Re: Okanogan Highlands Alliance (OHA) Comments to the proposed DSEIS for expansion of the Key Mill Tailings Storage Facility – Stack Height Raise

**Comments on the Draft Supplemental Environmental Impact Statement (DSEIS) for the
Key Mill Tailings Storage Facility - Filtered Tailings Stack Height Raise**

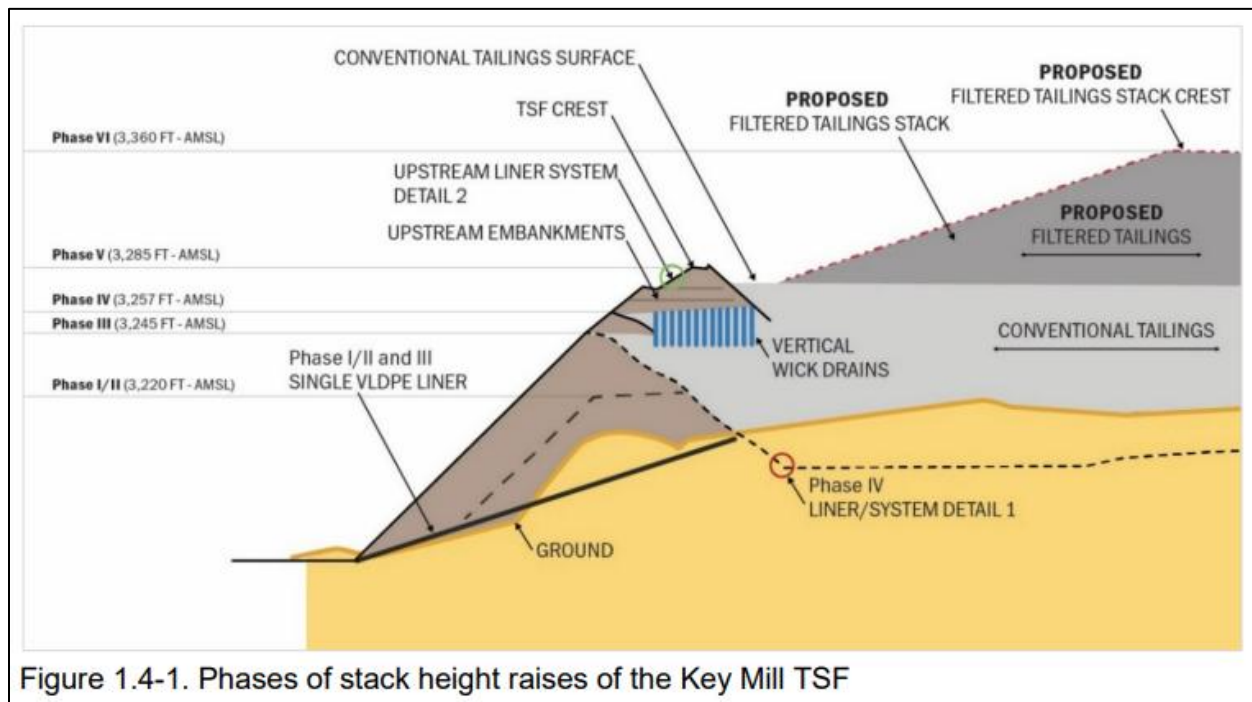
The filtered tailings storage facility would be constructed on top of an existing tailings storage facility that was constructed using the upstream method (see Figs. 1a-b, 2) with the excessively steep slope of 1V:2H (1 meter vertical for two meters horizontal) (see Fig. 3). The upstream construction method was known to be unsafe even three decades prior to the use of the method at the Key Mill Tailings Storage Facility. The construction of outer embankments with such excessively steep slopes was known to be unsafe at the time of construction of these embankments at the Key Mill Tailings Storage Facility.

Figure 2. The filtered tailings storage facility would be constructed on top of an existing tailings storage facility that was constructed using the upstream method (compare with Fig. 4a). The upstream construction method was known to be unsafe even three decades prior to the use of the method at the Key Mill Tailings Storage Facility. Figure from WSDE (2026, pdf p. 21).

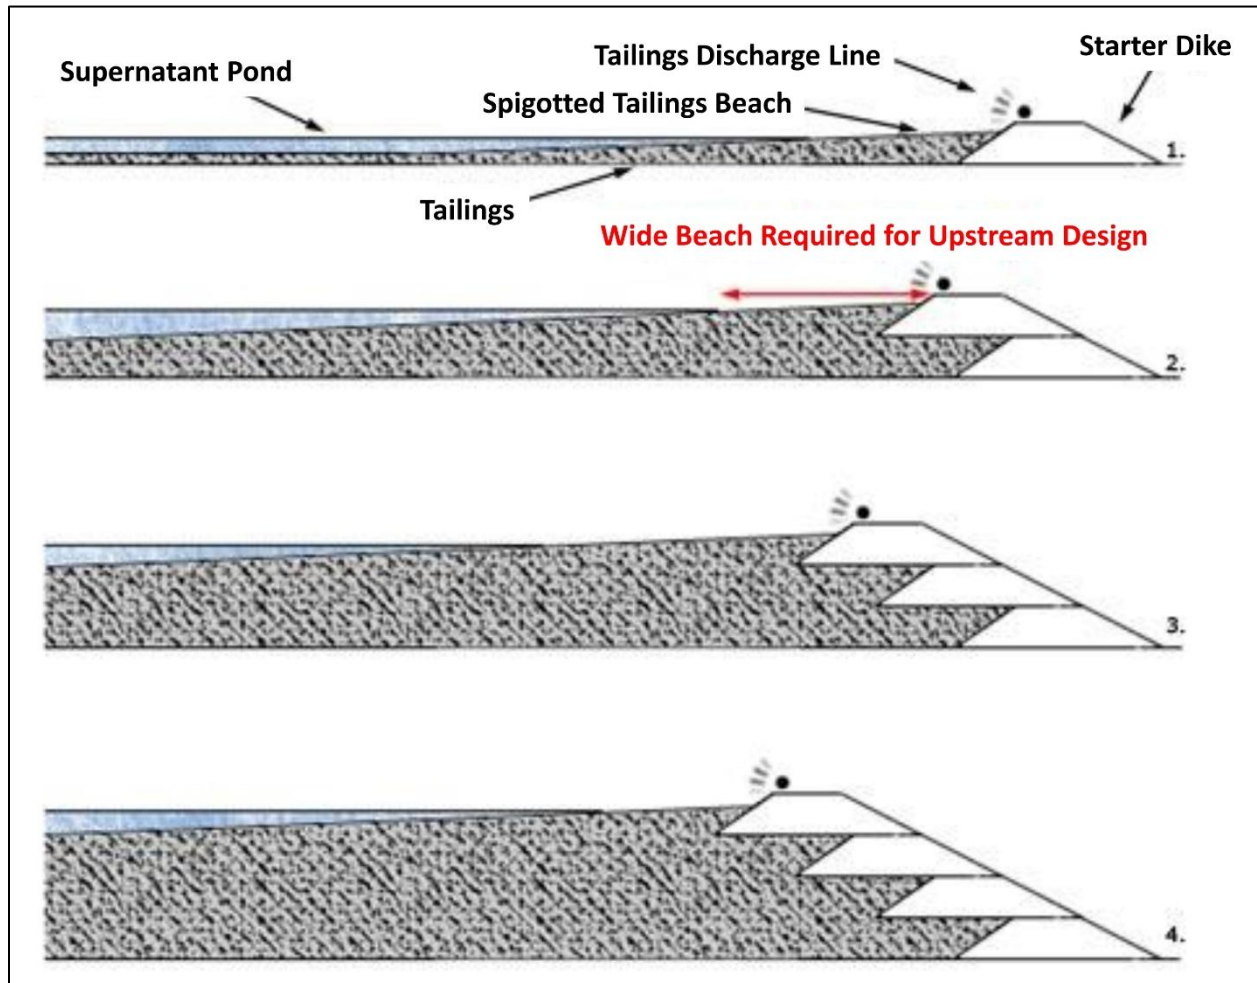
From another perspective, an upstream dam is constructed on top of an unknown foundation (see Fig. 4a; Fuller, 2019). An accurate knowledge of the foundation is an essential feature of dam safety since both tailings dams and water-retention dams have failed due to yielding or settling of the foundation. The geotechnical properties of the tailings underlying the dikes can be predicted, but they are not actually known until they can be measured after dikes have been constructed on top of them. In the same way, the future evolution of the tailings (for example, due to compaction by the overlying dikes or drying of the tailings) can be predicted, but is not actually known until the future has occurred. This feature of upstream dams sets them apart from any other type of dam in which the geotechnical properties of the foundation can and should be a known quantity before the dam is constructed.

Figure 4a. In the upstream construction method, successive dikes are built in the upstream direction as the level of stored tailings increases. Dikes can be constructed with mine waste rock, natural soil, natural rock fill, or the coarser fraction of tailings (with proper compaction). The advantage of the method is its low cost because very little material is required for the construction of the dam. The disadvantage is that the dam is susceptible to failure due to seismic or static liquefaction because the non-compacted wet tailings are below the dam. For this reason, the upstream construction method is illegal in Brazil, Chile, Ecuador and Peru. Dams constructed by this method are also susceptible to flood failure when the beach is too narrow due to an insufficient amount of sand in the discharged tailings or excessive water in the settling pond. Figure from TailPro Consulting (2026).
